# TOLEDO-LUCAS COUNTY PLAN COMMISSIONS

REF: SUP-9005-18

SUBJECT: Request for an Amendment to a Special Use Permit, originally approved by Ord. 160-89 and Ord. 65-06, for gas station rebuild at 3504 Lagrange Street.

# SITE PLAN

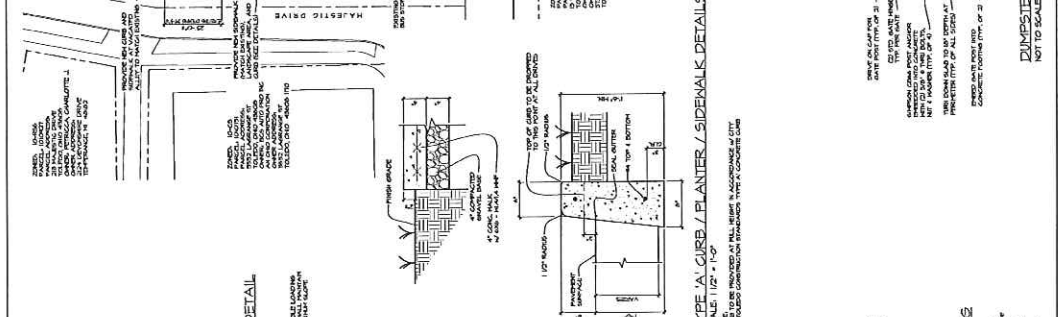
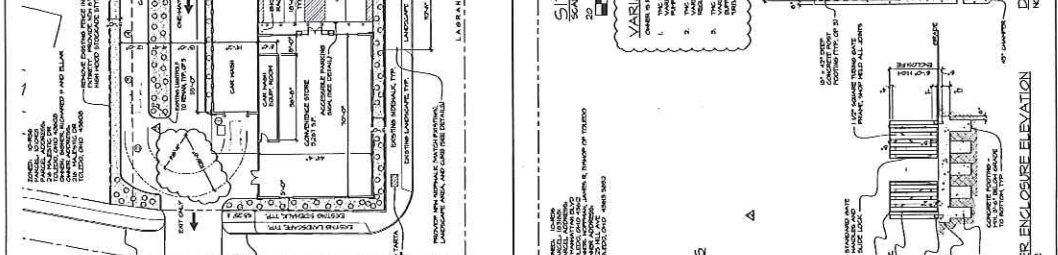
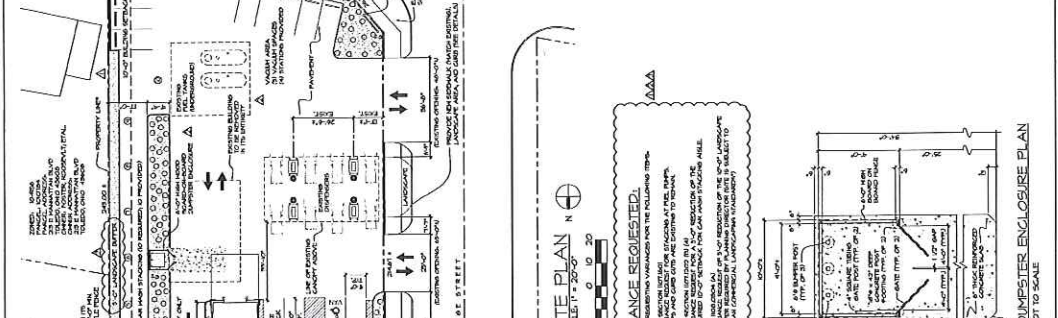
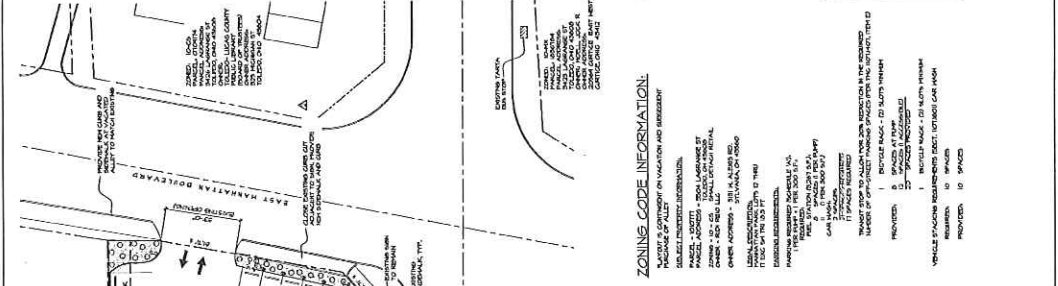
Pursuant to TMC§1107.1202(B), off-street parking facilities, including vehicular drives and maneuvering areas, in Commercial or Industrial districts are prohibited within twenty-five feet (25') from Residential districts. The site plan submitted depicts parking spaces and the car wash stacking lane within this required setback along the residential properties to the east. As a result, the applicant has requested a waiver of twenty-feet (20') to allow the car wash stacking lane in its current location. The three (3) parking spaces abutting the residential property shall be removed in order to comply with the regulation and listed as a condition of approval.

The Division of Transportation has not objected to the proposed site plan although they have identified several issues which are included as conditions of approval. These issues have been attributed to the proposed addition of the car wash which limit the maneuverability of the site. First, 10'x20' vehicle stacking is required on both sides of gas pump islands required and the stacked vehicles at the gas pumps would block the drive aisle. Second, a 25' wide drive aisle from vehicle stacking spaces is required for two-way traffic. Third, no driveway to Majestic Drive is permitted. Vehicles will not obey one-way signage and could potentially stack out into Majestic Drive. Additionally, the curb cut on Lagrange Street closest to Manhattan Boulevard shall be closed. Finally, the existing curb cuts and approaches of the vacated alley will need to be removed and the new curb to match existing adjacent curb. A suitable layout to the Division of Transportation was determined in a meeting prior to the submitted site plan, but was not followed. A revised site plan shall be submitted addressing the Division of Transportation's conditions of approval.

30. Curb cut on Lagrange Street closest to Manhattan Boulevard shall be closed.
31. Existing curb cuts and approaches of vacated alley to be removed. New curb to match existing adjacent curb.
32. A suitable layout to Division of Transportation was determined in a meeting prior to this revised plan, but was not followed.

38. Pump islands shall be set back a minimum of 15 feet from the property line. **Not acceptable as depicted on site plan submitted. Plan Commission recommended approval of waiver to TMC§1104.0903 (B) in order to allow for the pump islands within 15 feet of the property line.**

41. Off-street parking facilities, including vehicular drives and maneuvering areas, in Commercial or Industrial districts are prohibited within twenty-five feet (25') from Residential districts (TMC§1107.1202(B)). **Not acceptable as depicted on site plan submitted. Plan Commission recommended approval of waiver to TMC§1107.1202(B). The three (3) parking spaces abutting the residential property shall be removed and depicted on a revised site plan.**

- b. Perimeter landscaping must be installed along any parking lot area adjacent to a street, place, or driveway. Perimeter landscaping must consist of a landscape area at least five-feet (5') in width, exclusive of easements, sidewalks, or rights-of-way, planted with at least one shrub for every three to five-feet (3-5') feet of property line, as determined by growth characteristics. **Not acceptable as depicted on site plan submitted. A minimum of forty-nine (49) plantings shall be installed along the eastern property line where the site abuts the residential district and depicted on a revised landscaping plan.**

Approve a waiver of twenty-feet (20') from the required twenty-five feet (25') to allow an off-street parking facility, including vehicular drives and maneuvering areas, when abutting a Residential district.

33. A revised site plan shall be submitted satisfying the Division of Transportation's conditions of approval.
34. All previous conditions of approval from SUP-262-88 (*Ord. 160-89*) & SUP-6007-02 (*Ord. 65-06*) shall apply and remain in effect.
35. The adjacent alley shall be vacated in order to allow for the expansion of the gas station.
36. A Petition to City Council shall be submitted for a Zone Change from RS6 Single-Dwelling Residential to CS Storefront Commercial in order to allow for the expansion of the gas station on the proposed vacated alley.
